***SECTION 75W MODIFICATION REQUEST
(MP 06_0162 MOD 8)
Barangaroo Concept Plan
Hickson Road, Barangaroo***

Secretary's
Environmental Assessment Report
Section 75W of the
Environmental Planning and Assessment Act 1979

March 2016

Figure 67: Vehicular access into Block Y from Barangaroo Avenue (Source: Lend Lease / Crown)

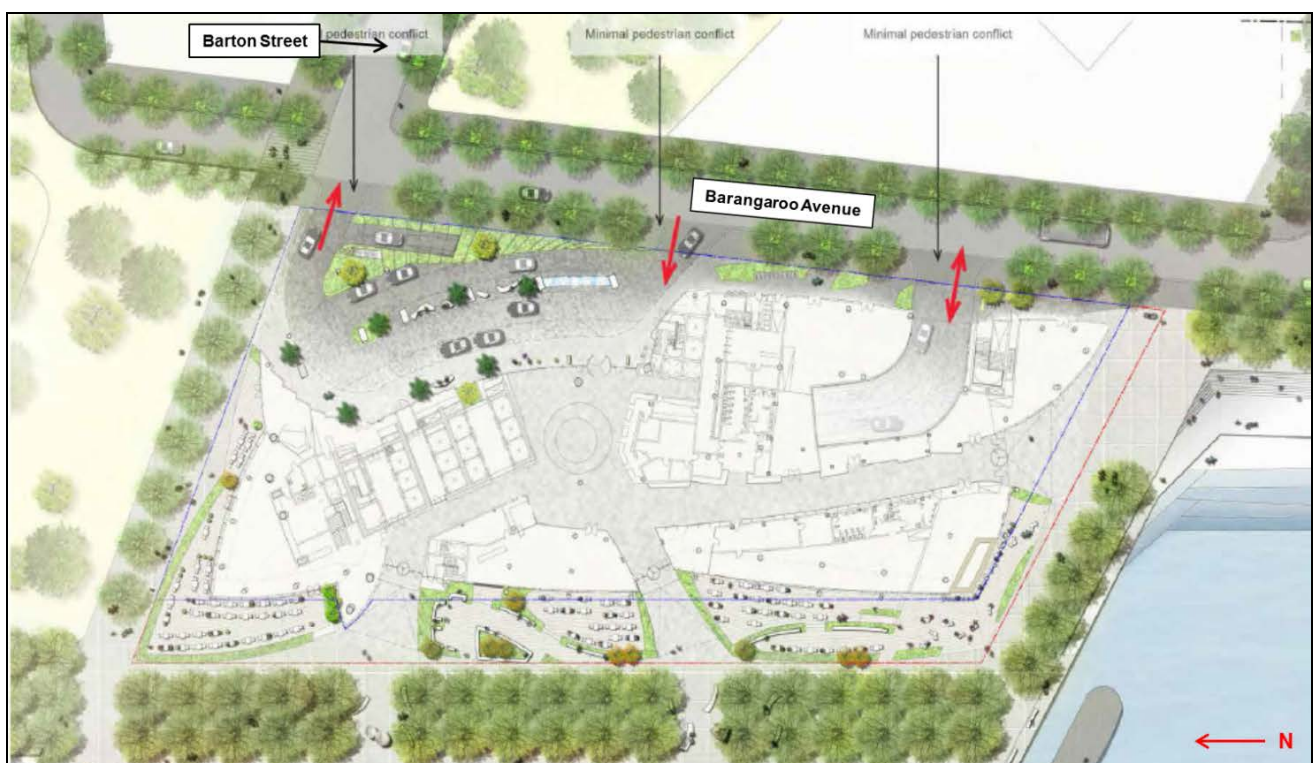
The DAP has also raised concerns about the potential traffic and pedestrian conflict in the vicinity of Block Y and Hickson Park (see **Figure 67**) and has recommended that the design of the street network, parking and delivery access points and the porte cochere of Block Y minimise pedestrian conflict.
